ACCESSION NBR: 8108140048 DOC. DATE: 81/08/10 NOTARIZED: NO DOCKET: #
 FACIL: 50-397 WPPSS Nuclear Project, Unit 2, Washington Public Powe 05000397
 AUTH. NAME: BOUCHEY, G.D. AUTHOR AFFILIATION: Washington Public Power Supply System
 RECIP. NAME: SCHWENCER, A. RECIPIENT AFFILIATION: Licensing Branch 2

SUBJECT: Forwards responses to Geosciences Branch 810504 second round questions. Responses will be incorporated into FSAR. Remainder of responses will be transmitted by 810930.

Subject: SUPPLY SYSTEM NUCLEAR PROJECT NO. 2
RESPONSES TO ROUND TWO QUESTIONS
GEOSCIENCES BRANCH

Reference: Letter, R. L. Tedesco to R. L. Ferguson, "WNP-2 FSAR -
Request for Additional Information", dated May 4, 1981.

Project No. 14940	Hanford FSAR	PROGRAM "MEVENT" RESIDUAL WEIGHTING USING TRUNC = 4.0	Figure 361.10-1
Woodward-Clyde Consultants

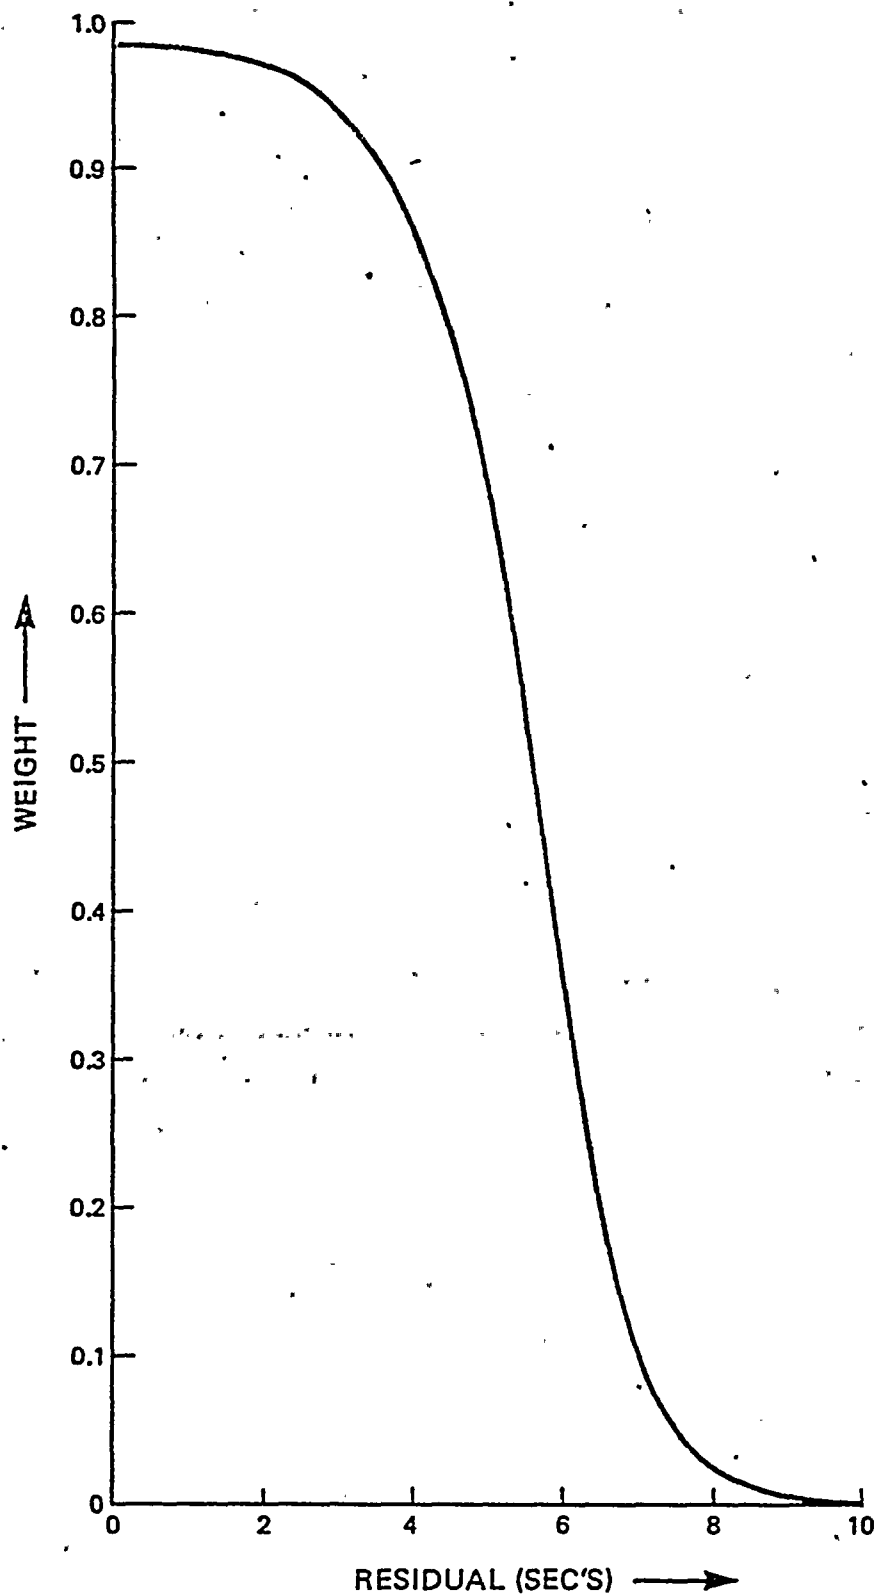
With regard to the Woodward-Clyde Consultants' report referred to in question 9, above, the report states that the teleseismic location program, MEVENT (Dewey, 1971) was used to relocate the Milton-Freewater earthquake. The program MEVENT allows for flexibility in assigning weightings to recorded earthquake arrival times. How were the station readings weighted in the relocation, and how do stations with large residuals (for example, 8.5 and 9.9 seconds) affect the relocation?

TRUNC is the program input parameter that determines the severity of weighting out larger residuals and has the dimensions of variance. TRUNC should be approximately equal to the sample variance of the P-wave observations being processed. The value of 4.0 was selected for TRUNC in locating the 1936 earthquake and is generally greater than the observed variances. This station weighting function is shown in Figure 361.10-1. The solution used in the 1980 report converged after five iterations. Beyond the residual weights for stations SEA and FER (with residuals 8.5 seconds and 9.9 seconds, respectively) were less than 0.02, the influence of the readings for these two stations on the computed location was effectively eliminated.
